Flores 24" Rehab Project- DR No 128
Solicitation Number: CO-00107-SM
Job No.: 14-4657

ADDENDUM 3
February 6, 2017

FLORES 24-INCH REHAB PROJECT, DR 128

REVISIONS
 FLORES 24-INCH REHAB PROJECT, DR 128
 TRAFFIC CONTROL PLAN
 ROAD DETOUR LAYOUT
 ALTERNATIVE - SEGMENT A

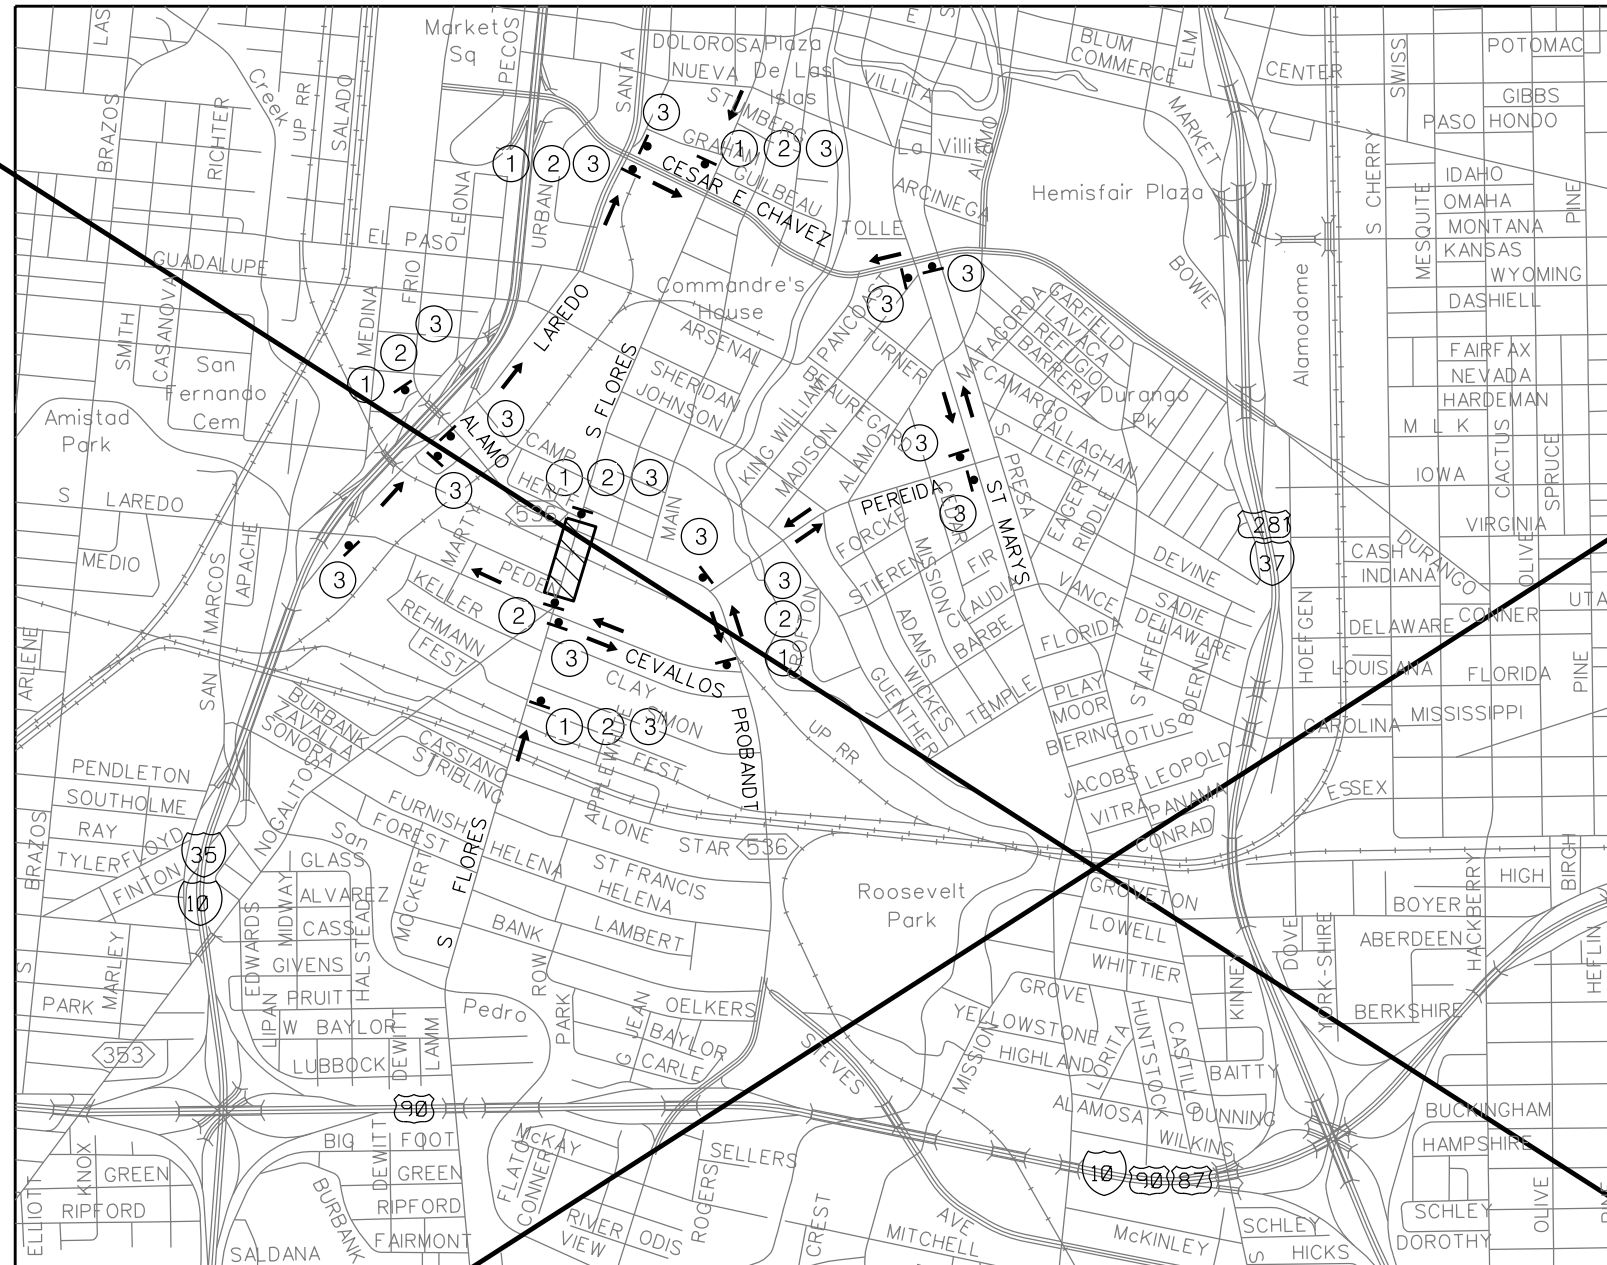
Sheet 30-32: Alternative TCP has been removed

R: Alternate TCP for full street closure is being deleted from the project (See Changes to the Drawings below).
